**Staff Report for a Single Family Home in the Canemah Historic District
June 19, 2017**

FILE NO.: HR 17-01: Historic Review Board review of construction of a new single family residence in the Canemah National Historic District.

REQUEST: Construction of a new single family dwelling in the Canemah Historic District.

RECOMMENDATION: Approval with Conditions

SHEET #
A2.1
ELEVATIONS

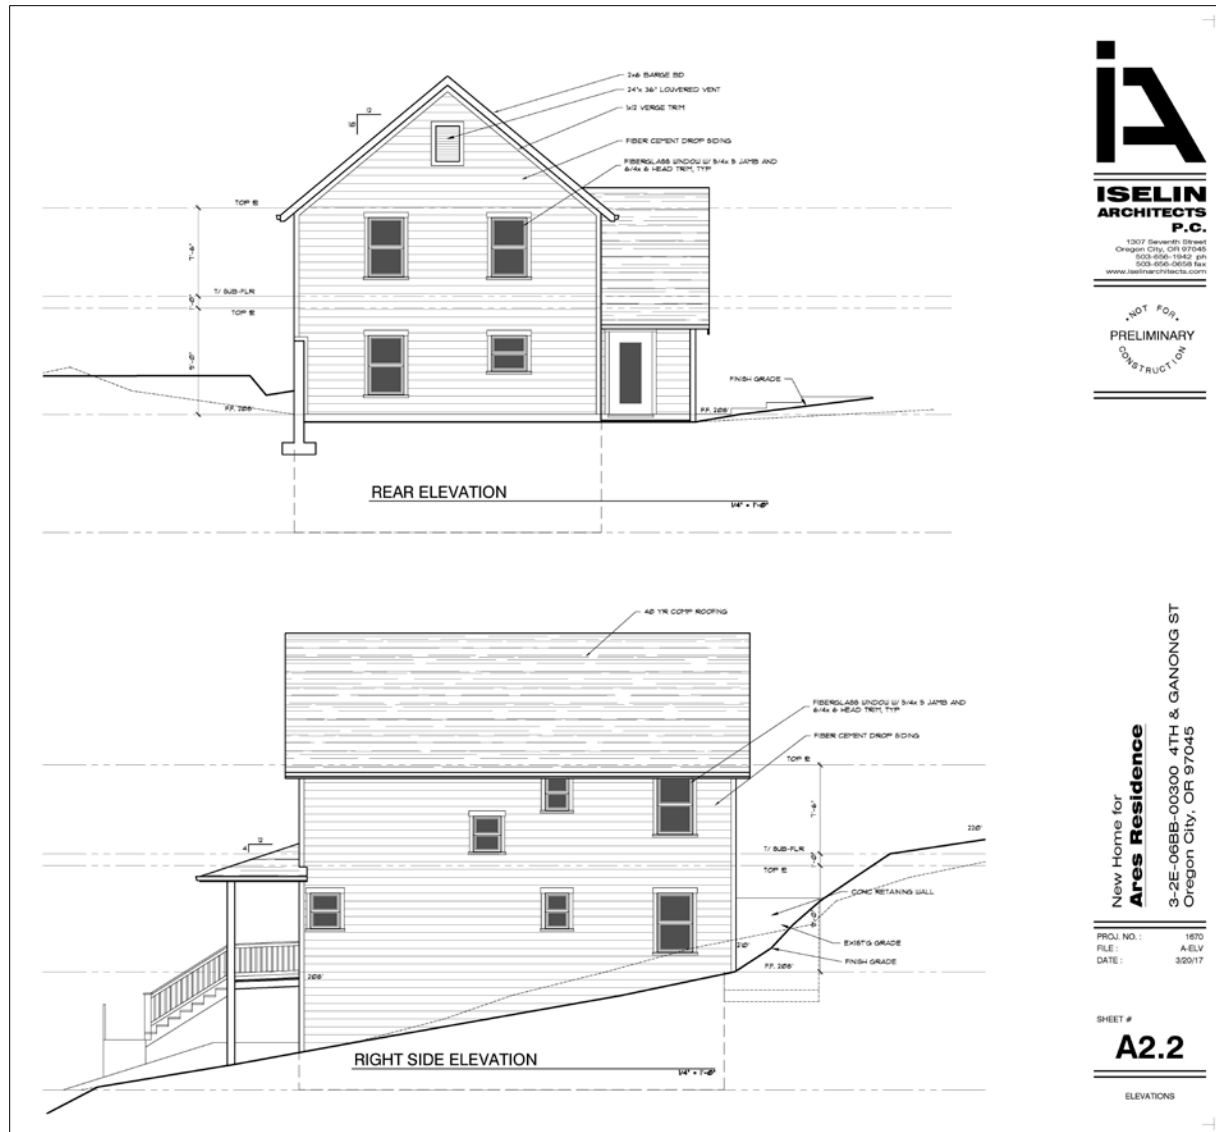
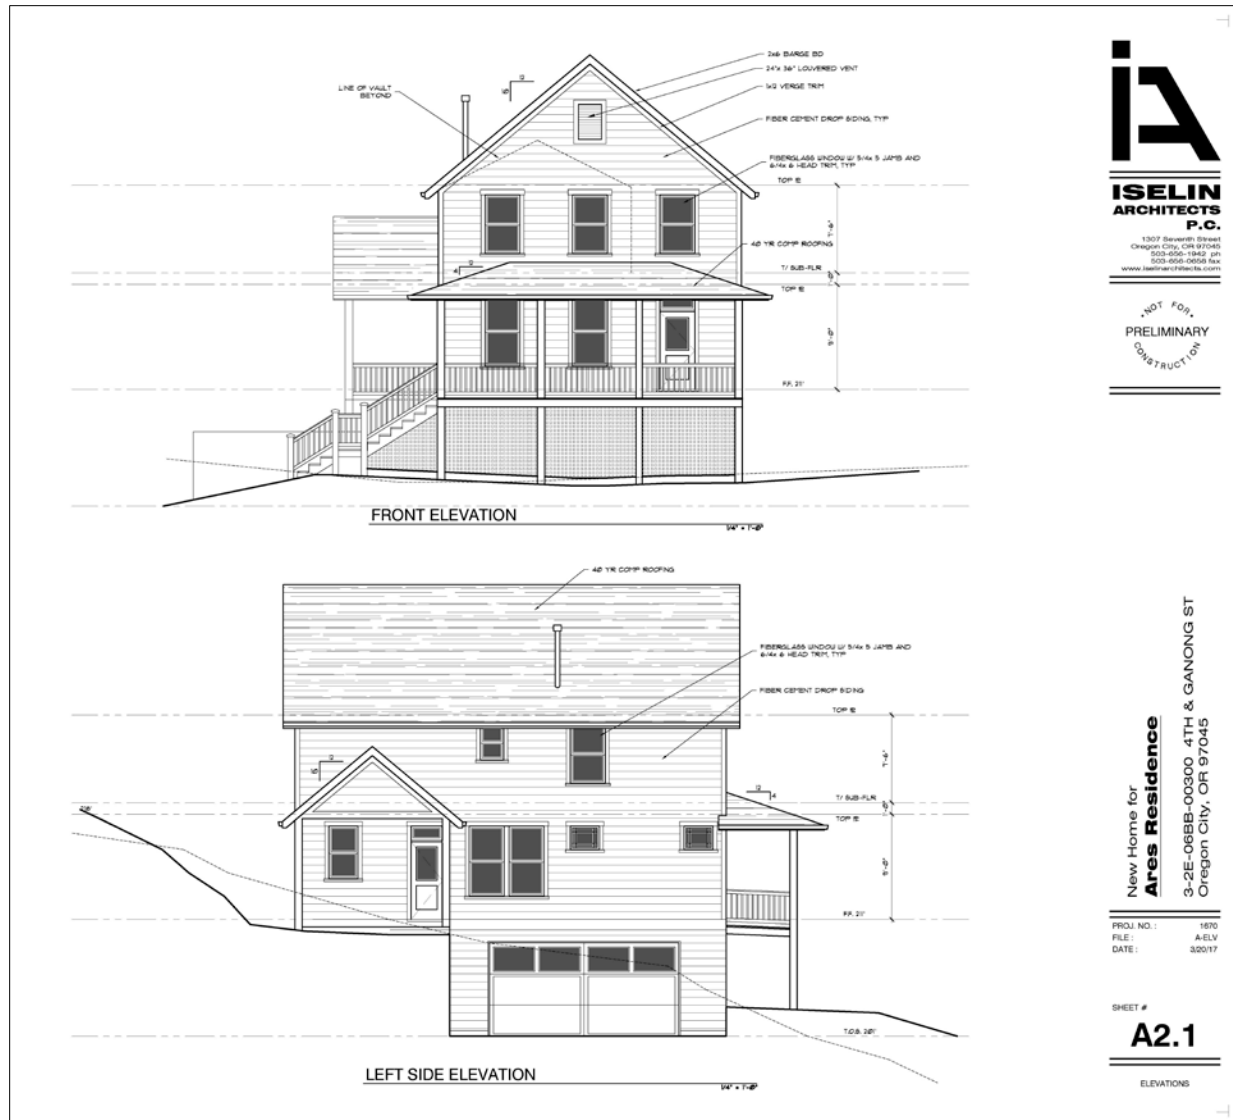
In the elevation drawing provided by the applicant there is significant basement massing on the north and west side of the proposed home.

Staff has identified massing along the north and east side of the proposed home. The home has been set back approximately 20 feet from the adjacent right-of-way to help mitigate for the massing along the right-of-way. The applicant should incorporate landscaping into the design of the home to help reduce the impact of the new home on the surrounding neighborhood. The applicant shall address the massing on the front and east side of the home, incorporating the existing vegetation would help to mitigate for the impacts of the proposed massing on the surrounding neighborhood. To mitigate for the massing in the front of the home one tree (at least 10 feet in height when mature) and four shrubs (at least 3 ½ feet in height when mature) shall be install in front of the home.

There is significant amount of vegetation located on the subject site, and the applicant has indicated on their site plan which of the existing vegetation will be removed and what vegetation will remain. The applicant shall address the massing on the front and east side of the home, incorporating the existing vegetation would help to mitigate for the impacts of the proposed massing on the surrounding neighborhood. To mitigate for the massing in the front of the home one tree (at least 10 feet in height when mature) and four shrubs (at least 3 ½ feet in height when mature) shall be install in front of the home.
